Town of The Blue Mountains

Date: June 6, 2024

Re: Bay Street East Reconstruction Project - Public Information Centre #1

This memo is intended to provide a summary of the questions, comments and answers that were received prior to, or asked during, the Public Information Centre (PIC) held on April 18, 2024. The PIC was held virtually on Microsoft Teams from 5:00 p.m. to 7:00 p.m. A total of 55 individuals attended the meeting including Town staff and the project team.

Proposed Alternative for Bay St E. Forcemain

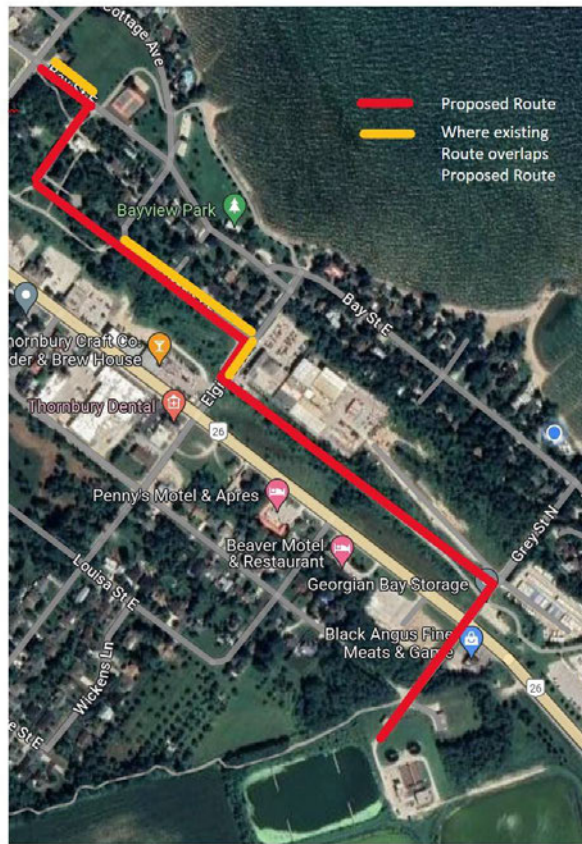
Based on the expanded list of design considerations the BSE community members are proposing an alternative forcemain alignment that is closer to Alternative C, as presented at the PIC. Specifically, the BSE community members feel that a path through the Cedar Grove area could make this route even more appealing (see below). This proposed alignment would have minimal impact to residents (3 homes on Huron St. East), traffic and mature tree canopy. Bike and pedestrian traffic from the Georgian Trail would be re-directed to Bay Street East while the forcemain is constructed. Following construction of the forcemain the Town would commence construction of the BSE water and sanitary remediation project. This smaller scope project could be completed faster with minimal disruption to residents and traffic, and the absence of the forcemain in the project scope means considerably less impact to BSE streetscape and tree inventory. The BSE residents believe that this new alignment approach is the best option to preserve the 'cottage road' character of the street while minimizing the overall 'real' total cost of construction. The BSE community members request that Council consider this valid forcemain alignment alternative.
